Access Compliance Report

Public Rights-of-Way

Intersection ID: 14533	Main Street: S_TORRENCE_ST	Cross Street: S_KINGS_DR	Location: NE
ADA ID: A24043B586DC	Ramp Type: PerpDiag	Initial Pass/Fail: Fail	Overall Compliance: No
		Severity Score: 50

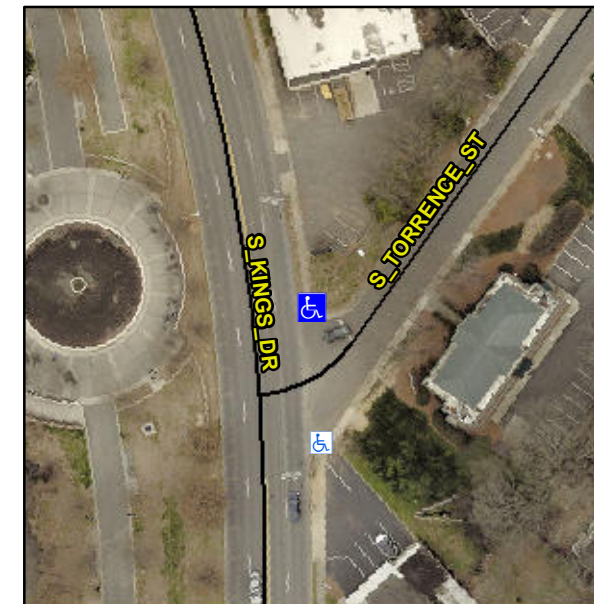
Not Found, R304.2.2, R304.5.3

Compliance	Description	Data	Compliance	Description	Data
N/A	Ramp Length (in)	60.0	No	Ramp Slope (%)	14.1
Yes	Ramp Width (in)	48.0	No	Ramp XSlope (%)	7.0
N/A	Flare Type LT	N/A	N/A	Flare Type RT	N/A
N/A	Flare Slope LT (%)	N/A	N/A	Flare Slope RT (%)	N/A
N/A	Flare Traversable LT?	N/A	N/A	Flare Traversable RT?	N/A
N/A	Landing Length (in)	N/A	N/A	DWS Provided?	N/A
N/A	Landing Width (in)	N/A	N/A	DWS Contrast?	N/A
N/A	Landing Slope (%)	N/A	N/A	DWS Length (in)	N/A
N/A	Landing X Slope (%)	N/A	N/A	DWS Full Width?	N/A
N/A	Landing Curb? (Y/N)	N/A	N/A	DWS Offset (in)	N/A
N/A	Shared Landing?	N/A			
N/A	Gutter Ponding?	N/A	N/A	Gutter Slope (%)	N/A
N/A	Gutter Lip Ht (in)	N/A	N/A	Gutter X Slope (%)	N/A
N/A	Painted X Walk1?	No	N/A	Painted X Walk2?	No
	X Walk 1 Direction	To W		X Walk 2 Direction	To S
N/A	X Walk 1 Width (in)	N/A	N/A	X Walk 2 Width (in)	N/A
	X Walk 1 Slope (%)	1.8		X Walk 2 Slope (%)	1.1
	X Walk 1 X Slope (%)	1.5		X Walk 2 X Slope (%)	5.5

Remove & Replace Curb Ramp With Two New Directional Ramps or Equivalent.
